工程指示 / 要求簡箋(E.I.)

工程指示編號：EI / 2377 / 20

工程編號：J - 852

工程名稱：亞皆老街中電

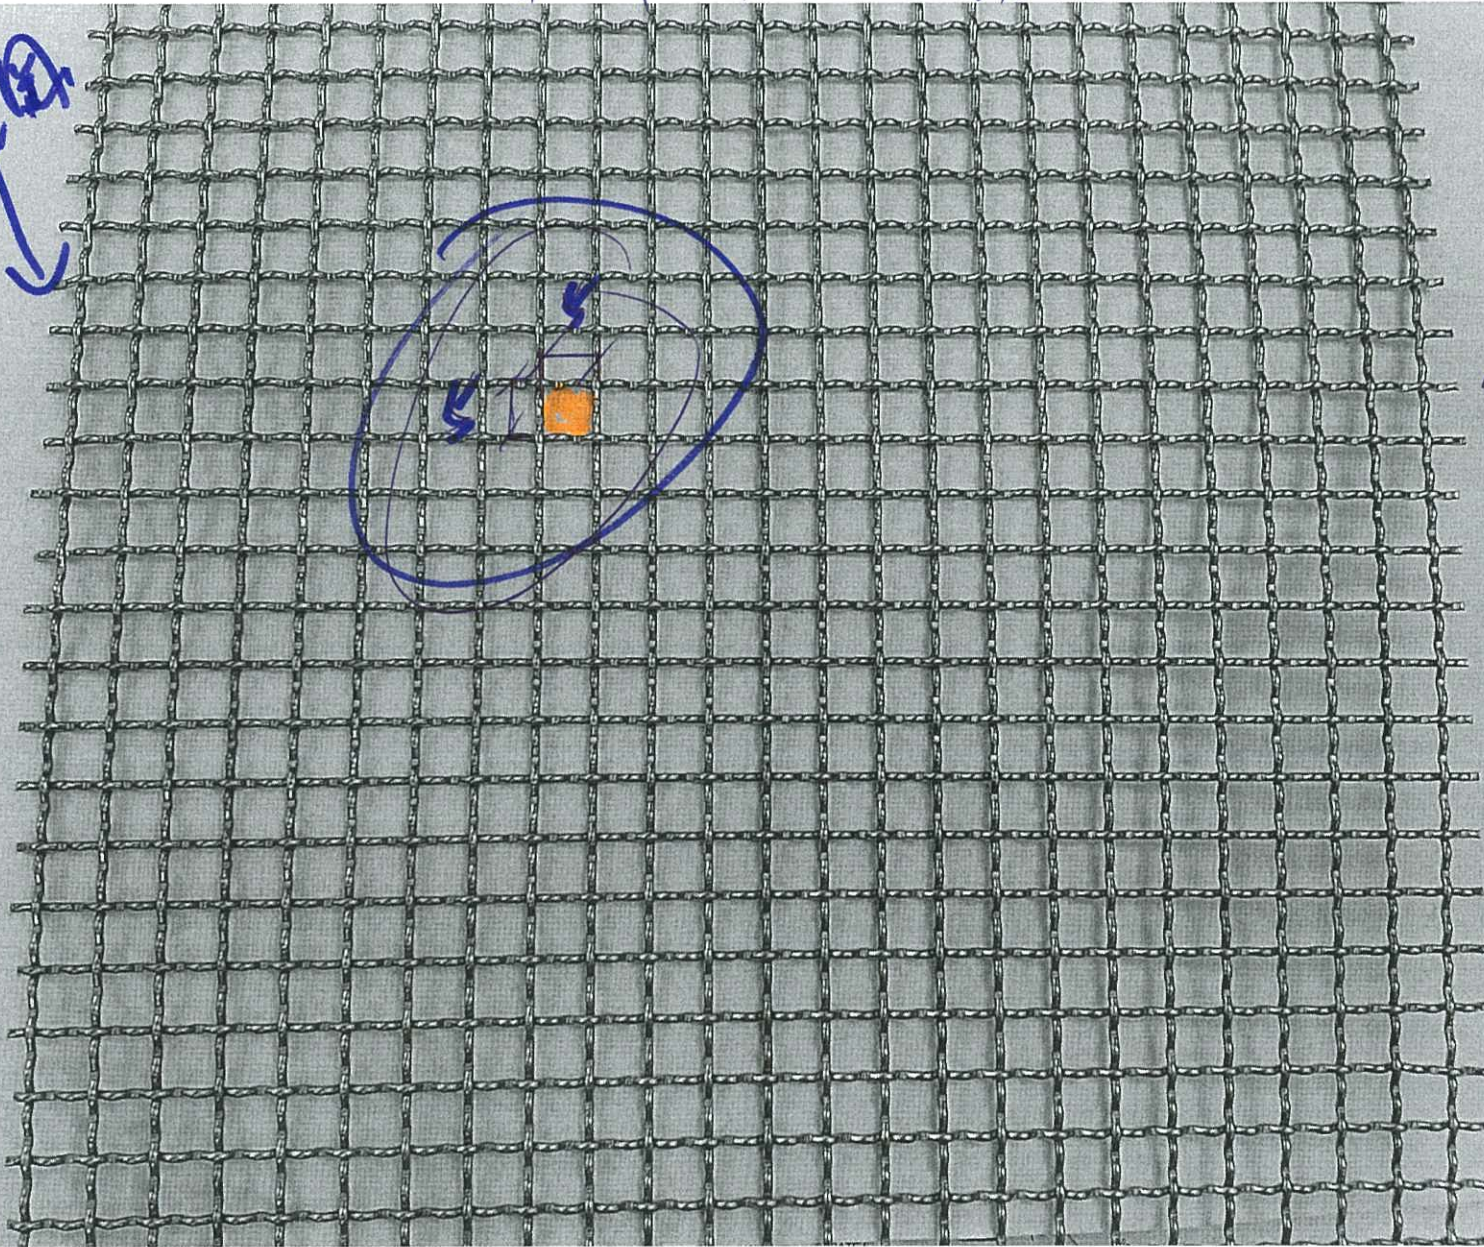
本工程百葉，如無背板全用雀網。(包括窗上百葉)

雀網：不秀鋼雀網 網眼 5X5

水洪：請安排拆圖。(包括窗上百葉)

本工務局用之鋼絲網 (2.5x2.5)

5x5
鋼眼
